PROPOSAL:

to permit the construction of one 6-storey apartment building consisting of 116 dwelling units in Fleetwood. A variance is proposed to reduce the minimum outdoor amenity space requirement under the CD Zone.

LOCATION: 15730 Fraser Highway

File No.:	7923-0080-00
New or Resubmit:	New
Last Submission Date:	N/A
Description:	Detailed Development Permit for one 6-storey apartment building consisting of 116 dwelling units with underground parking.
Address:	15730 Fraser Highway
Developer:	Matt Reid, Dawson & Sawyer
Architect:	Abhishek Sinha, Architect AIBC, Barnett Dembek Architects
Landscape Architect:	Mary Chan-Yip, PMG Landscape Architects
Planner:	Misty Jorgensen
Urban Design Planner:	Vanessa Goldgrub

DRAWING TITLE:
LANDSCAPE SHRUB PLAN

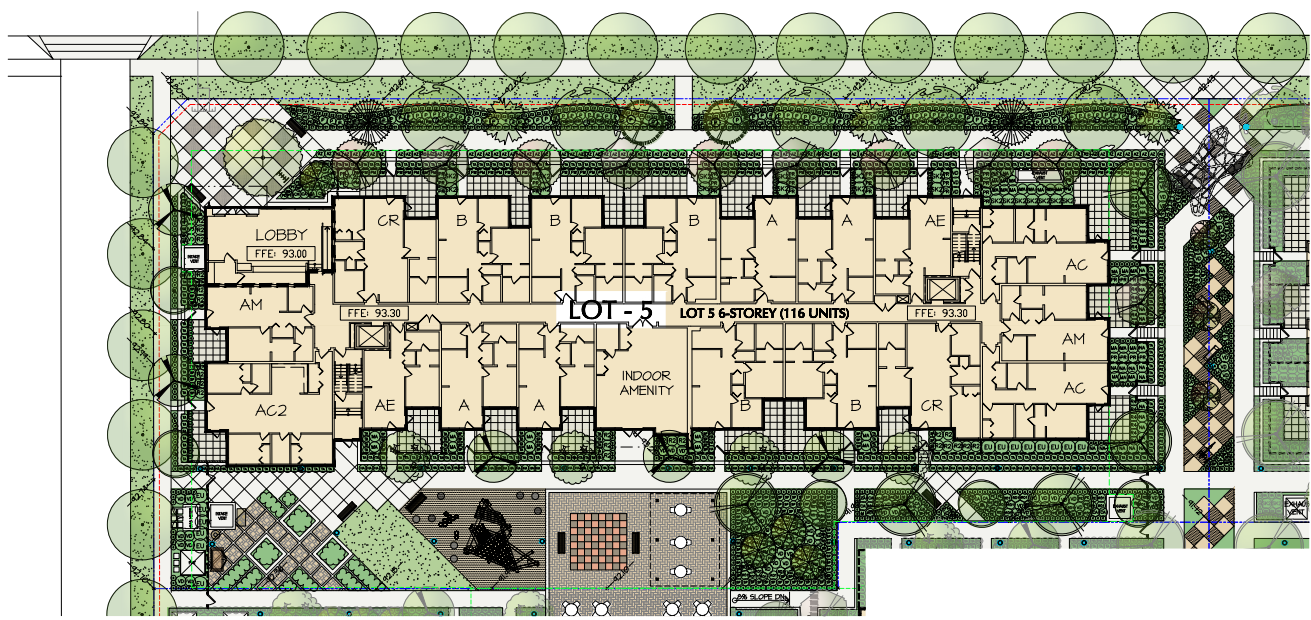
- Ensure all trees have adequate soil volume and depth. Completed. See L3.
- Considering adding some berming in the buffer planting between Fraser Highway and patios. Completed. An 18' berm has been added along Fraser Highway.

7 GARDEN PLOTS

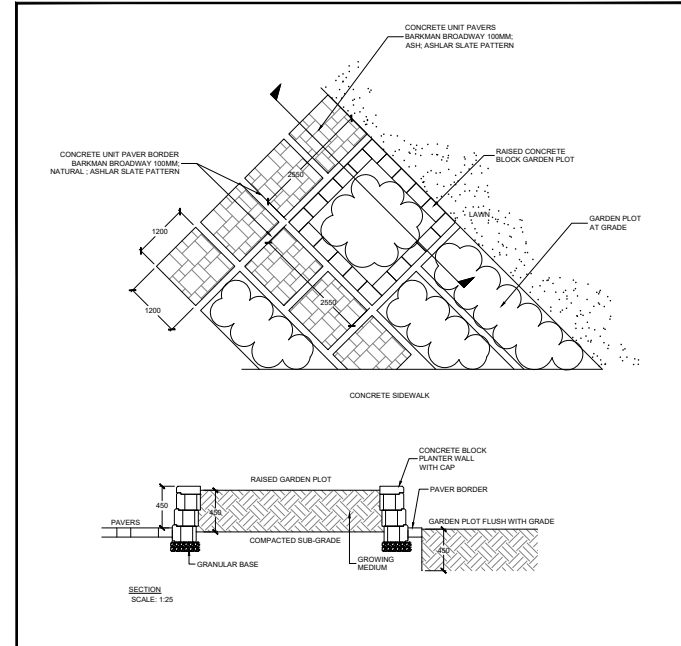
- Recommend providing 1-2 barrier-free/wheelchair accessible urban agriculture plots for universal access. **Completed. Three of the garden plots have been raised to provide accessibility.**
